RE: Response to First Technical Notice of Deficiency (TCEQ Tracking No. 30295149)
Greater El Paso Landfill (Type I)
Major Amendment Permit Application
TCEQ Permit Number MSW 2284A
El Paso County, Texas

PART I/II –EXISTING CONDITIONS SUMMARY AND SUPPLEMENTARY TECHNICAL REPORT

CITY OF EL PASO, TEXAS
GREATER EL PASO LANDFILL MAJOR
AMENDMENT
PROJECT NO. 155488

REVISION 3, MAY 16, 2025

Figure I/II.A.5.b
Wind Rose
Greater El Paso Landfill
MSW Auth #2284A
El Paso County, Texas

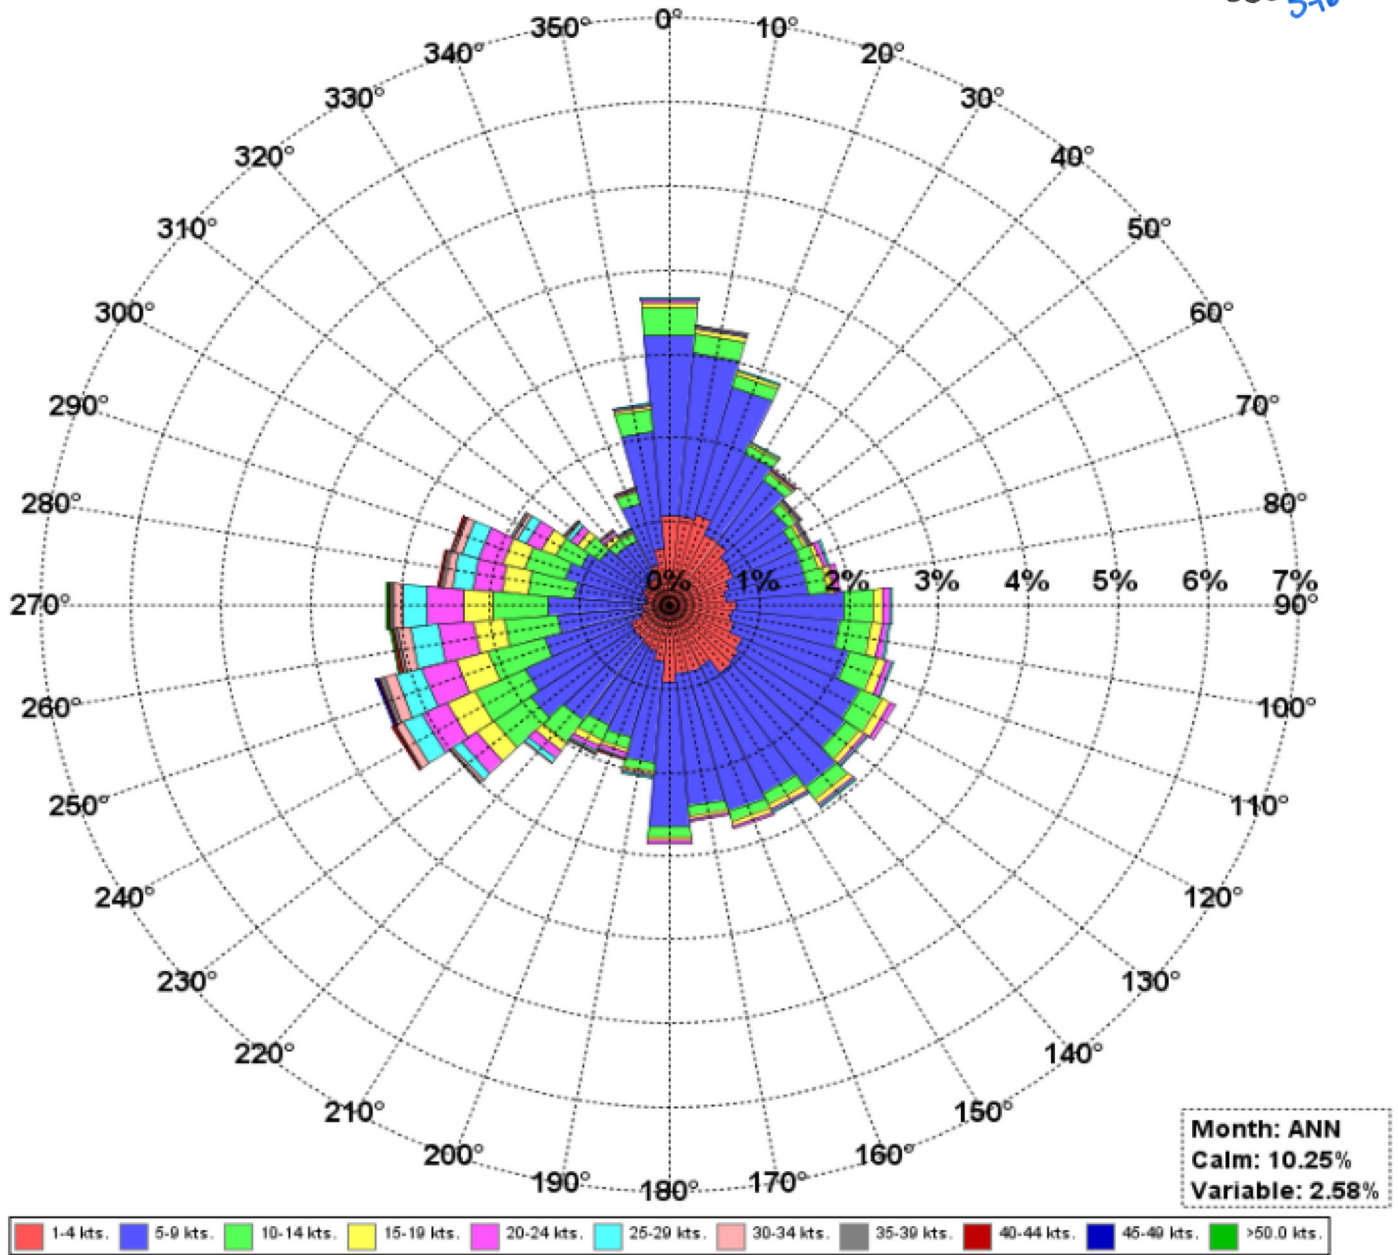
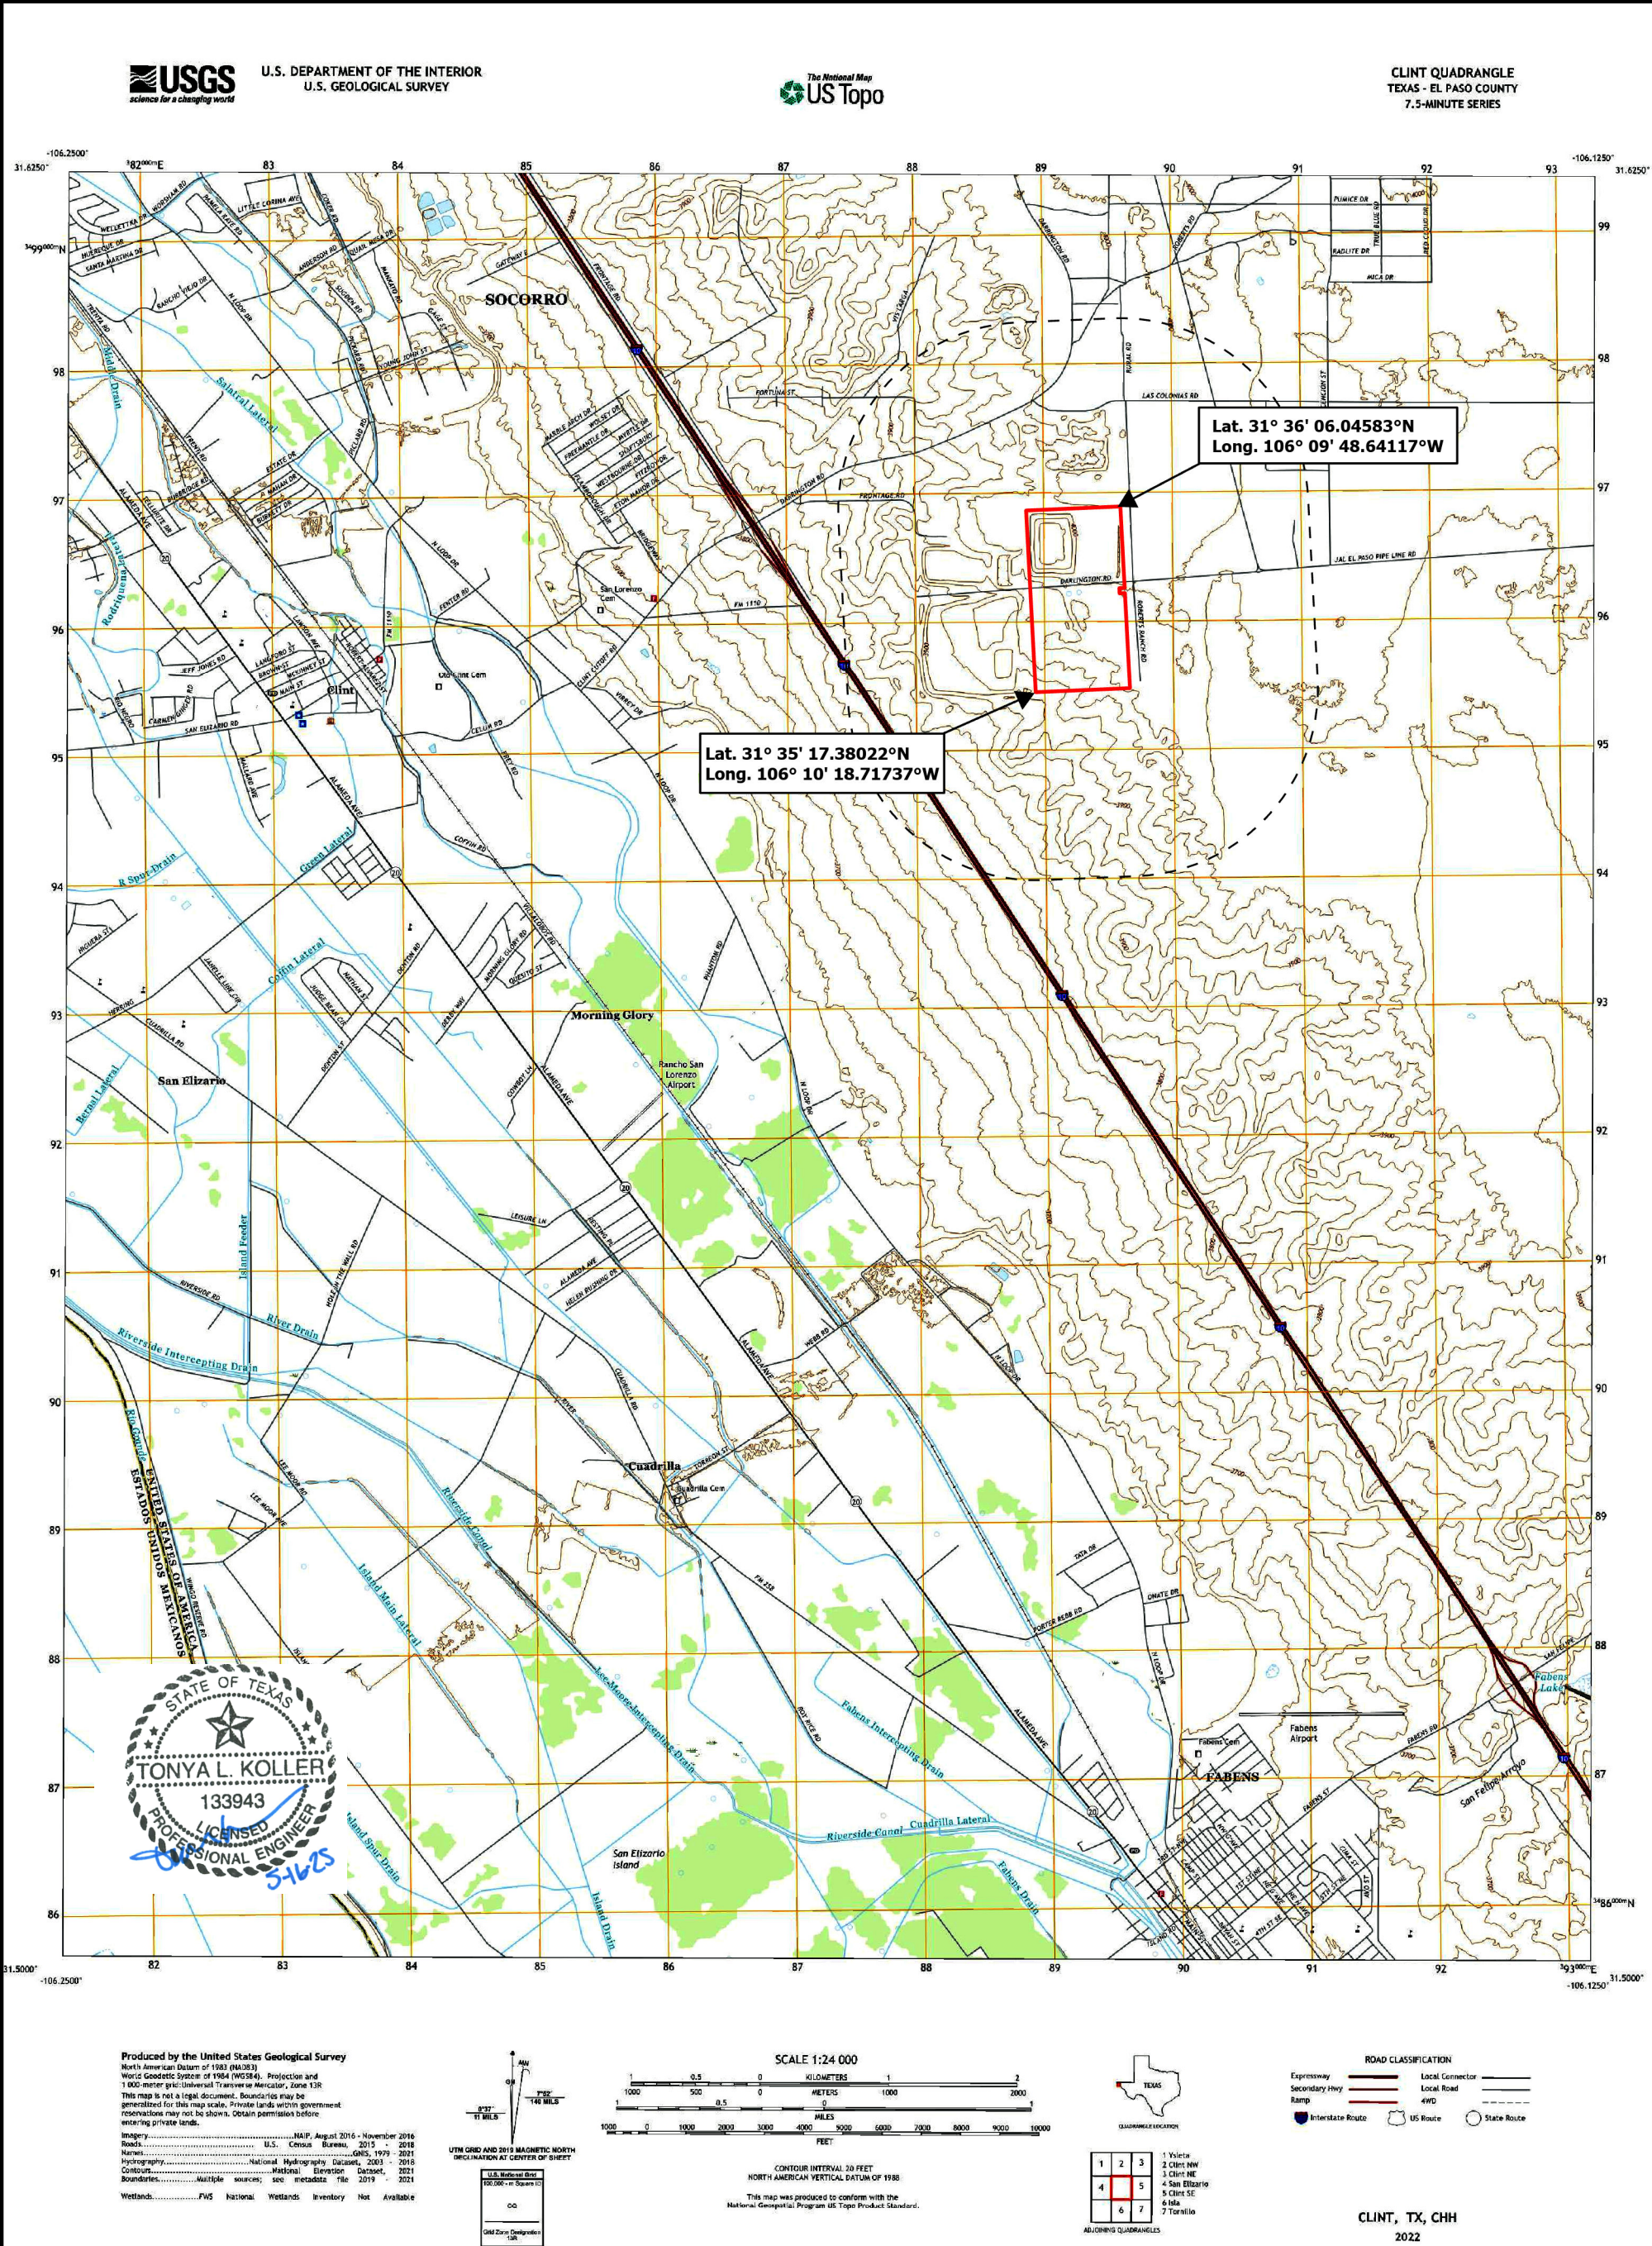
6	a) The wind rose is illegible or difficult to interpret in the provided figure. Increase the size of the wind rose on the current figure or provide a larger version of the wind rose as a separate page. b) The USGS 7.5-minute map is illegible or difficult to interpret. Provide an 11 by 17-inch page of the USGS 7.5- minute map.	The wind rose on Figure I/II.A.5 has been moved to a separate page, and is now Figure I/II.A.5.b in Appendix I/II.A. Figure I/II.A.6 in Appendix I/II.A has been reformatted to an 11 by 17-inch page.
7	Include the required acknowledgements regarding air pollution control and water pollution control in the application.	Part IV, Section IV.14.0 has been revised to acknowledge the requirements of 30 TAC §330, Subchapter U. Part III, Section III.2.3 has been revised to acknowledge the requirements of 30 TAC §330.55(b).
8	The latitude and longitude reported on Part I Form page 5 should be that of the benchmark. The benchmark elevation and coordinate information found on page I/II-52 and page I/II-55 are inconsistent. Revise these pages for consistency.	Section 12 in the Part I form as well as Figure I/II.B.2 in Appendix I/II.B have been revised to include the benchmark coordinate information as identified in the letter from Brock & Bustillos Inc. in Part I/II, Appendix I/II.B.

project	contract
155488	-
drawing	rev.
I/II.B.5	1
file: I/II.B.5 MAXIMUM ELEVATIONS.dwg

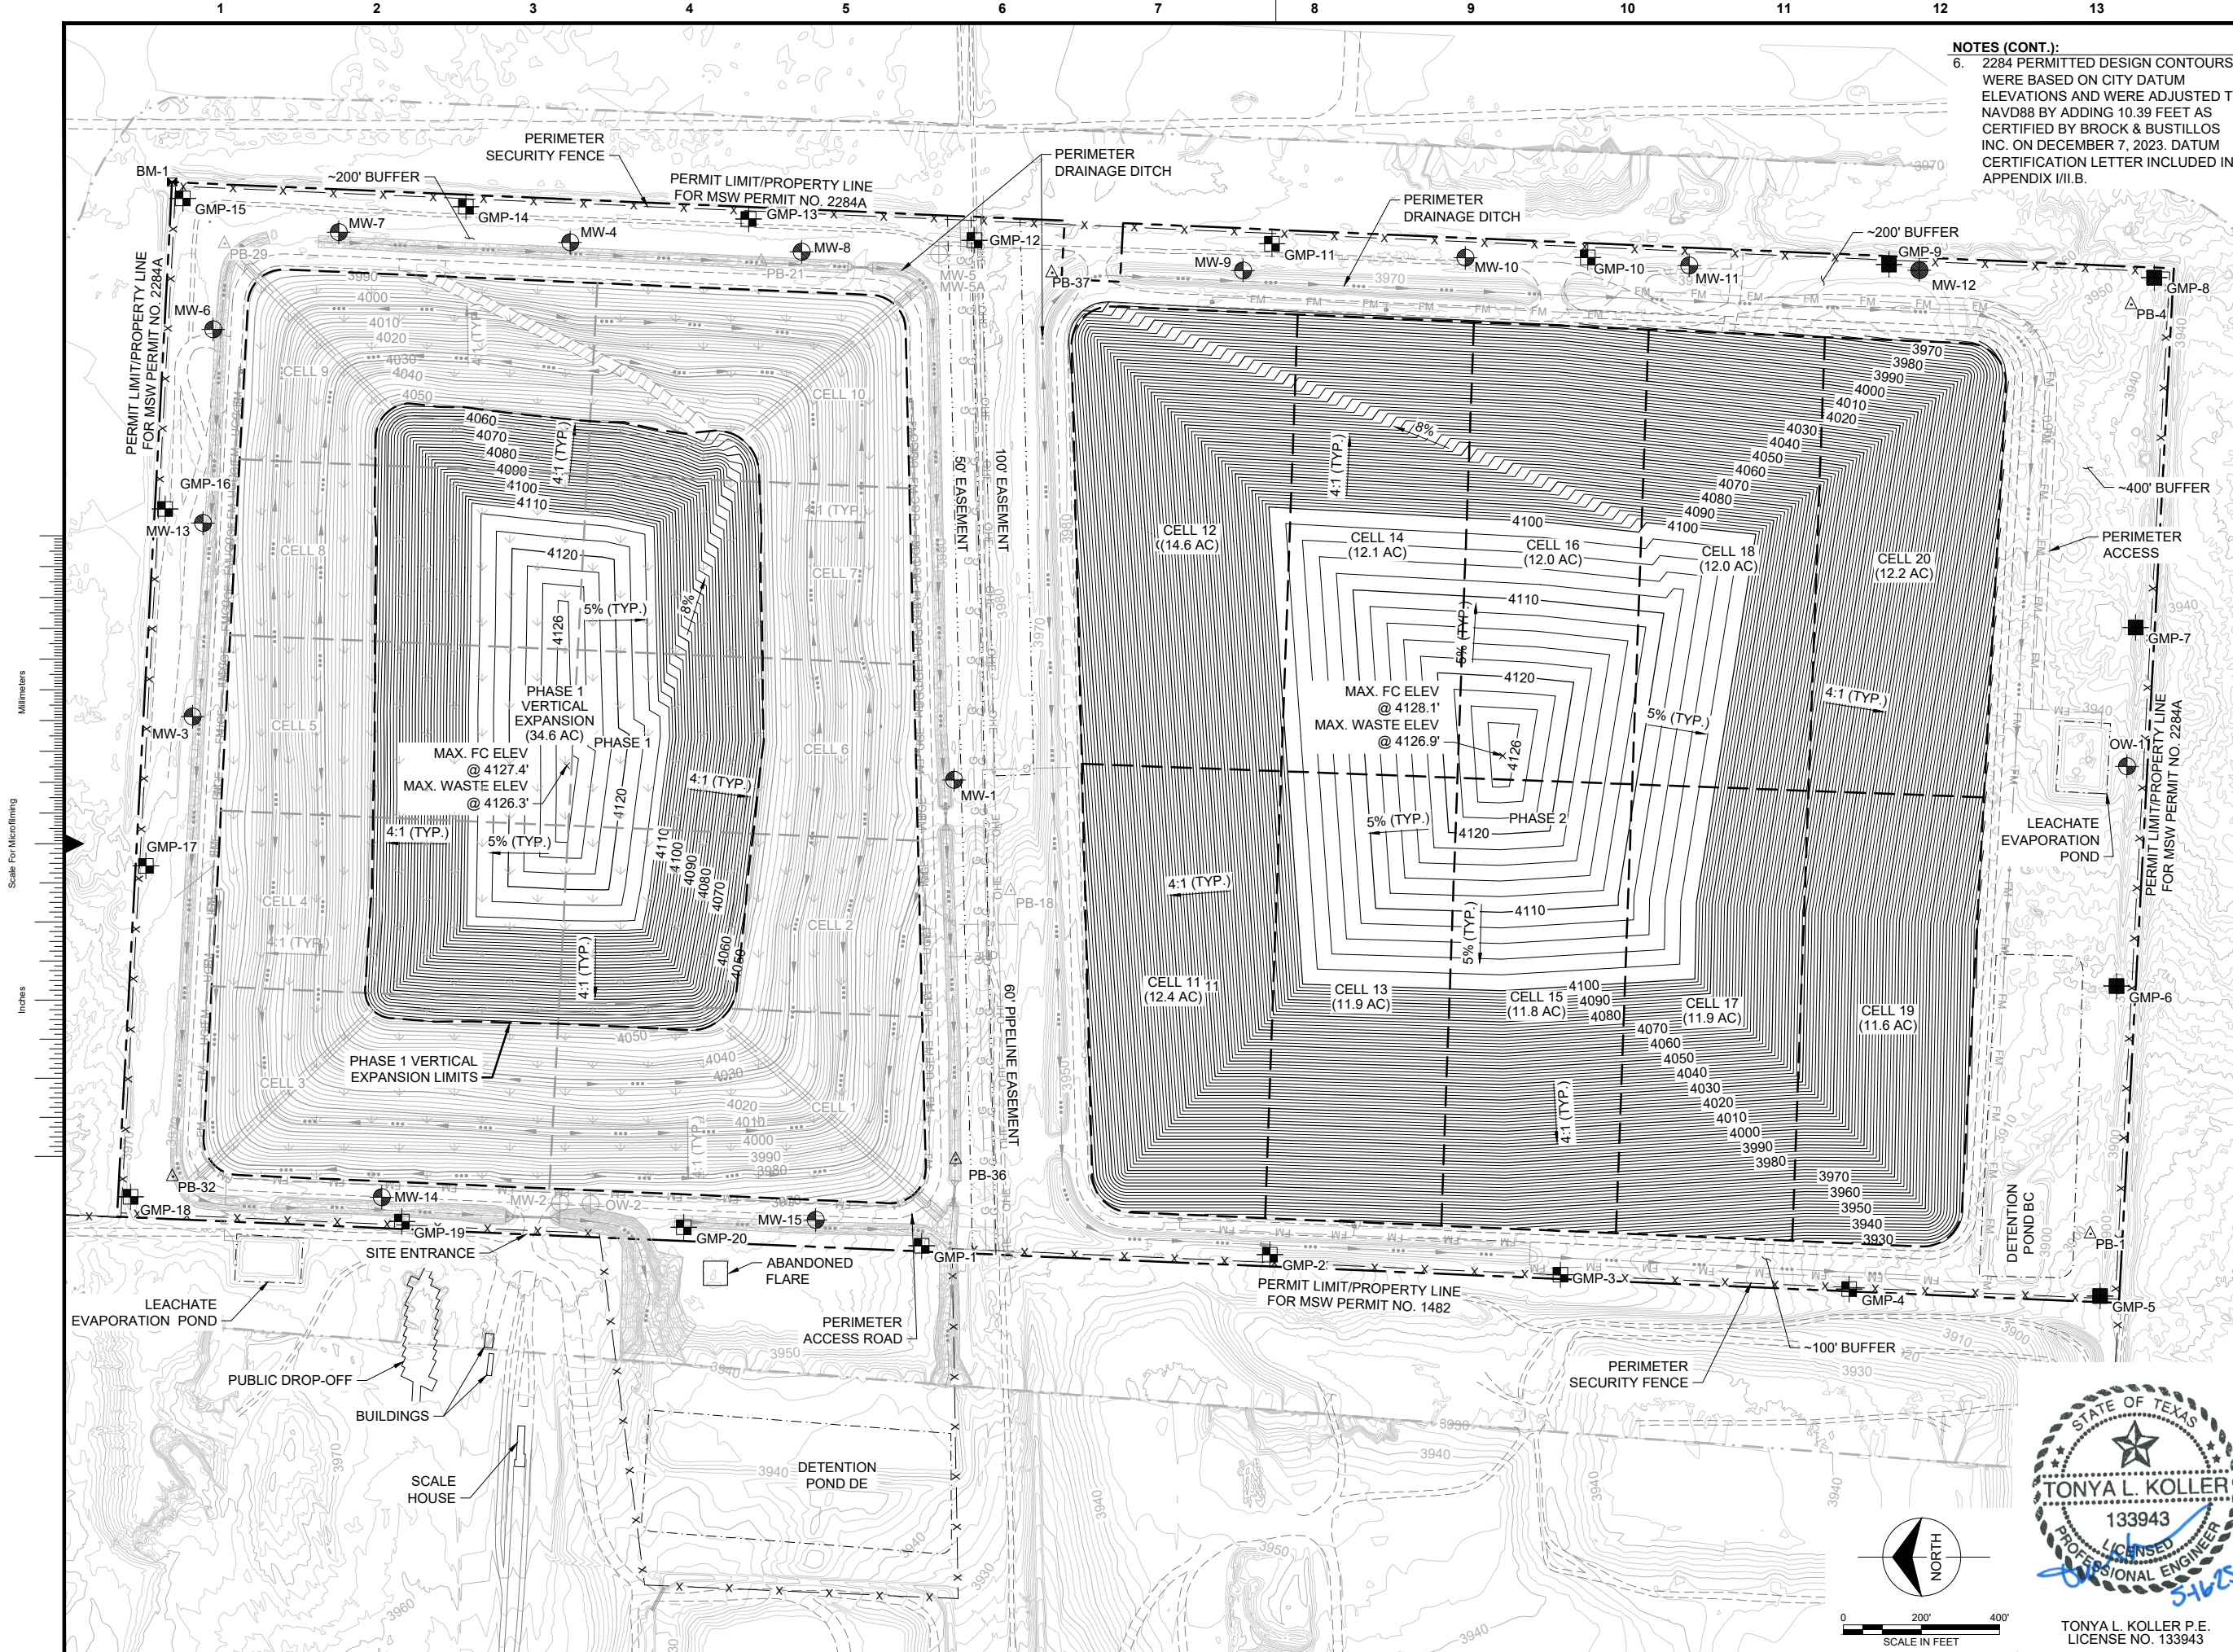
14	The maximum waste elevation and final cover elevation are inconsistent with Drawing III.A.10. Revise the drawings for consistency.	Drawing I/II.B.5 in Appendix I/II.B has been revised to accurately reflect the maximum final cover and waste elevations.
15	Provide schematic view drawings, as applicable, for each type of wastes received at the facility.	A schematic drawing is provided as Drawing III.A.3 in Part III, Appendix III.A. Waste enters the GEP Landfill from the public access road and is evaluated at the scale house. If accepted, MSW disposal occurs at the working face. Large items are managed at the public drop off area in accordance with Part IV, Section IV.13.0.
16	Provide ventilation and odor controls measures, including their design details, in the site development plan.	Part III, Section III.2.2 has been revised to state that landfill gas design details related to ventilation and odor control measures are discussed in Appendix III.H.
